## **Addendum No. 3**

The Transit Authority of the City of Omaha d/b/a Metro  
**Omaha Metro-Creighton University  
Multi-Modal Facility (Pedestrian Mall)**

Project No. NE-04-044 / Specification No. 34-17

Date Issued: 6-11-2018

Sheet Name:  
DEMO PLAN  
Sheet Number:  
**L-101**

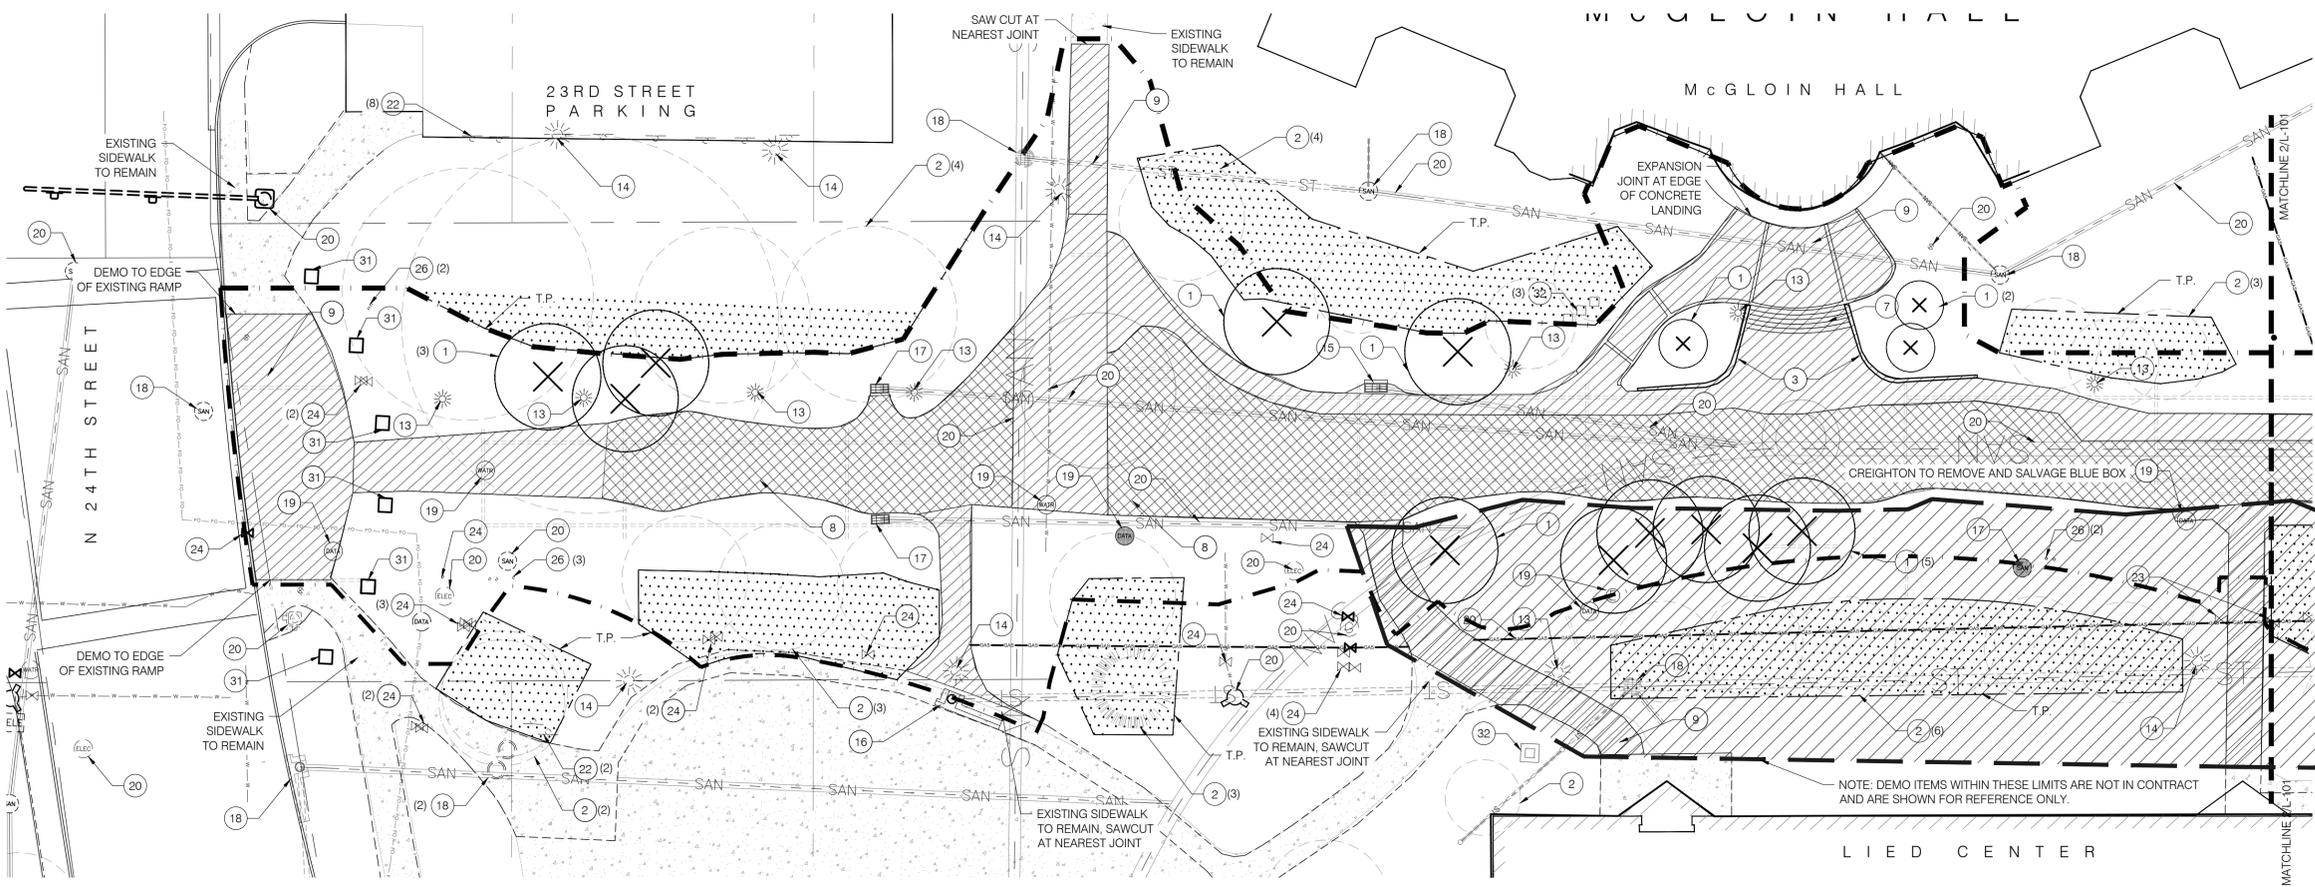
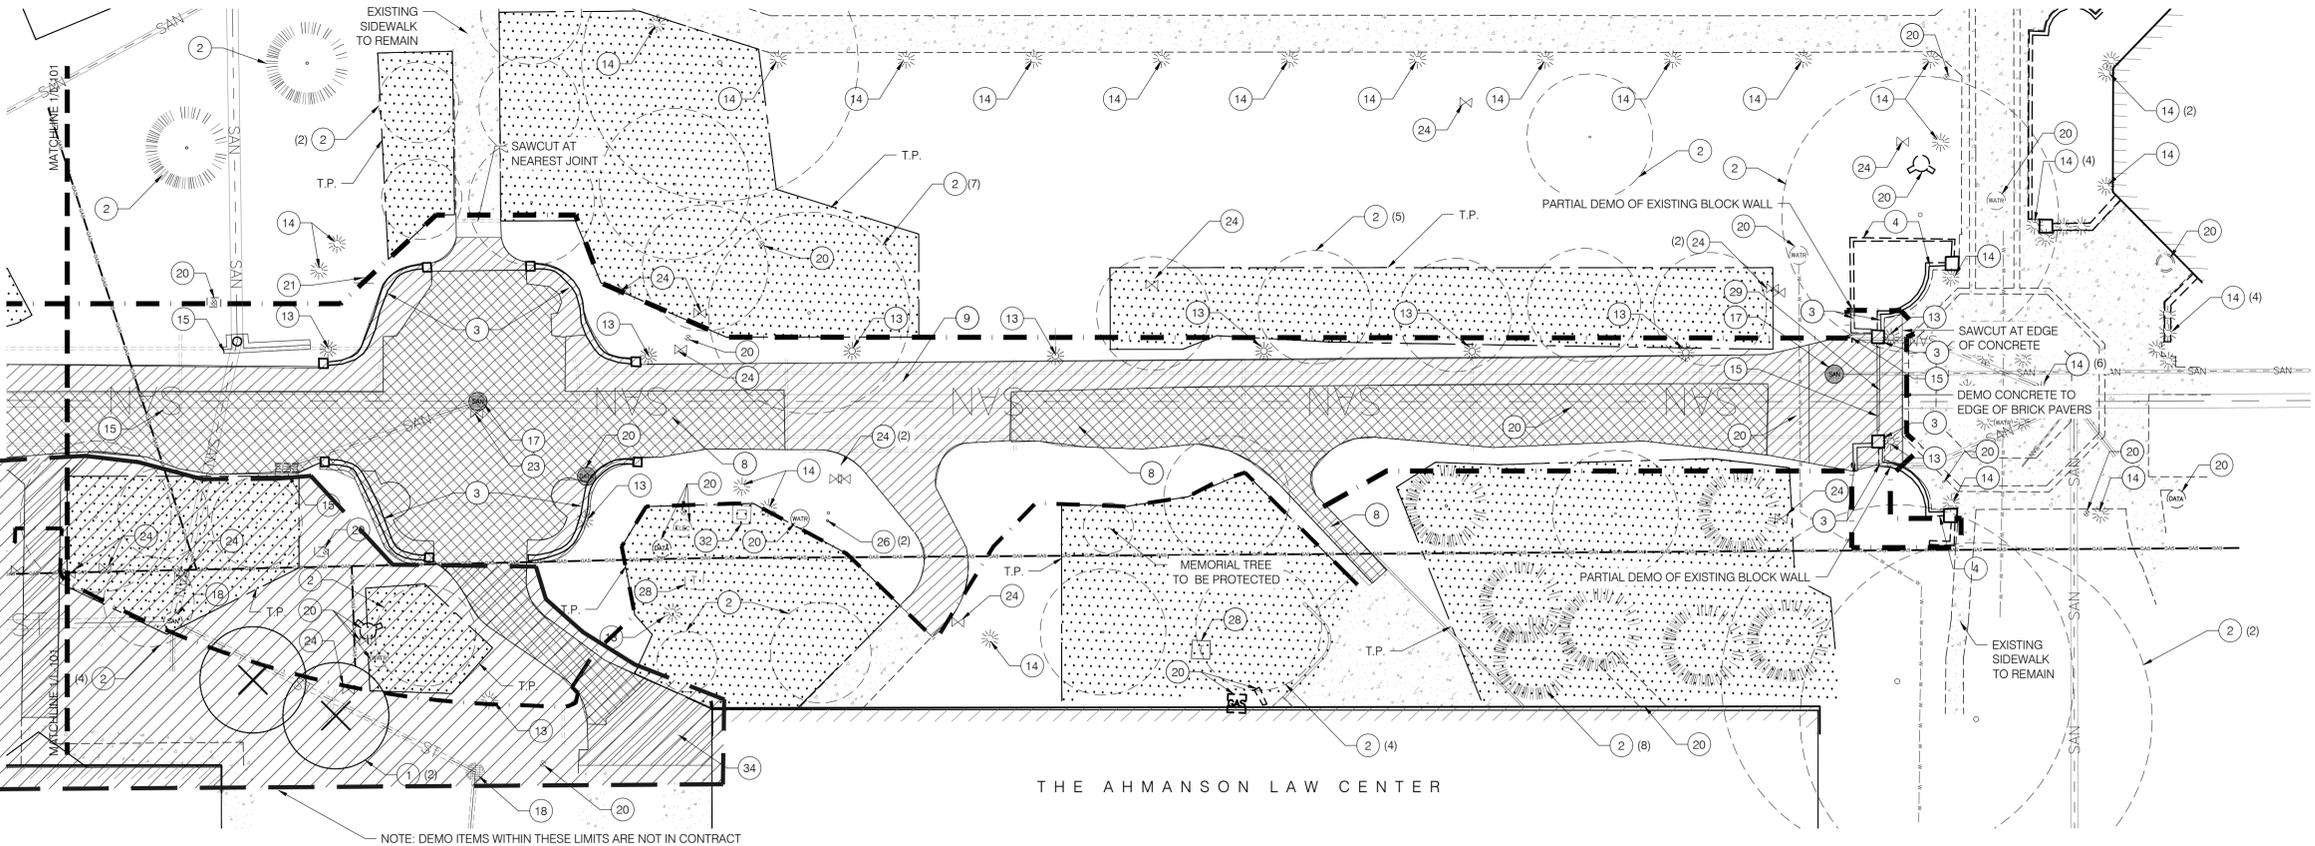
1. L-101 - Notes have been revised
2. L-203 -
3. L-300-304 - Notes updated to clarify paving patterns
4. L-500 and L-501 - Added notes to handrail and cheekwall detail
5. L-503 – Details revised
6. L-506 – Ash urn and backless bench deleted
7. C-101 – The depth of slab under the trench is 4". See note 2.
